NOTICE OF NON-PERFORMANCE

INSPECTION REPORT

Electrical Corporation:	PG&E
Report Number:	NON_ESD_PGE_AKM_20260311_1409
Inspector:	Akiko Masuda
WMP Year Inspected:	2025
Quarterly Data Report (QDR) Referenced:	Quarter 4 (Q4) 2025
Inspection Selection:	Energy Safety inspected the locations based on PG&E’s Q4 QDR.
Relevant WMP Initiative(s):	8.2.3.2 Wood and Slash Management
Date of inspection:	March 11, 2026
City and/or County of Inspection:	North San Juan, Yuba County

Photo 1: Photo of the ponderosa pine tree trunk measuring approximately 17 inches in diameter, consistent with the description for VMP ID VP_AV114-K19_561995.

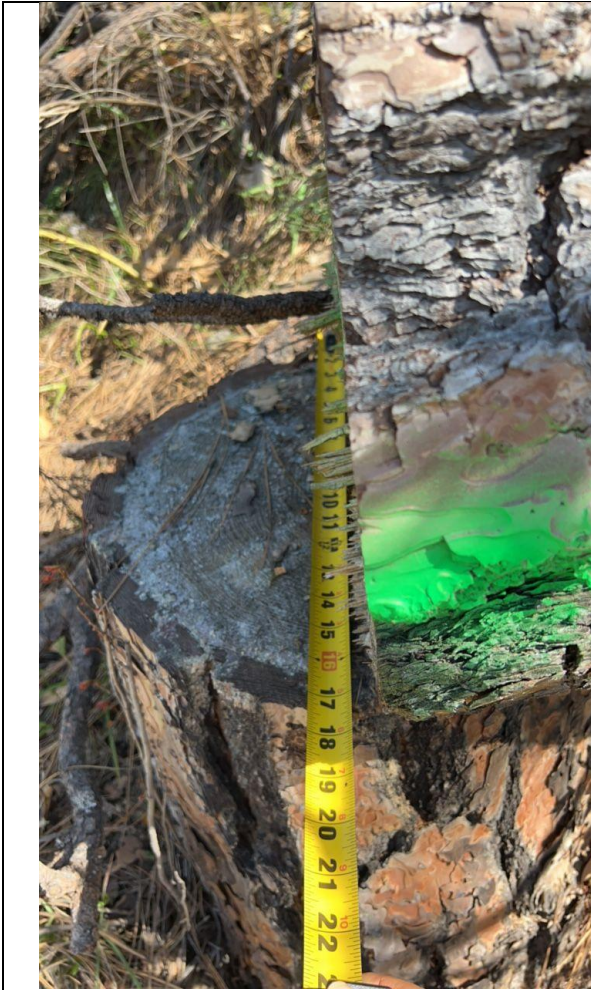
2, 2025. Energy Safety’s inspector observed that slash and woody debris from tree removal activities remained onsite, forming piles approximately 43 inches at its tallest point. The inspector’s observations are documented in Exhibit A photographs, which are attached to this report. Photos 1 and 2 depict the removed ponderosa pine tree trunks. Photos 3, 4, 5, and 6 depict the piles of wood and slash debris left on site.
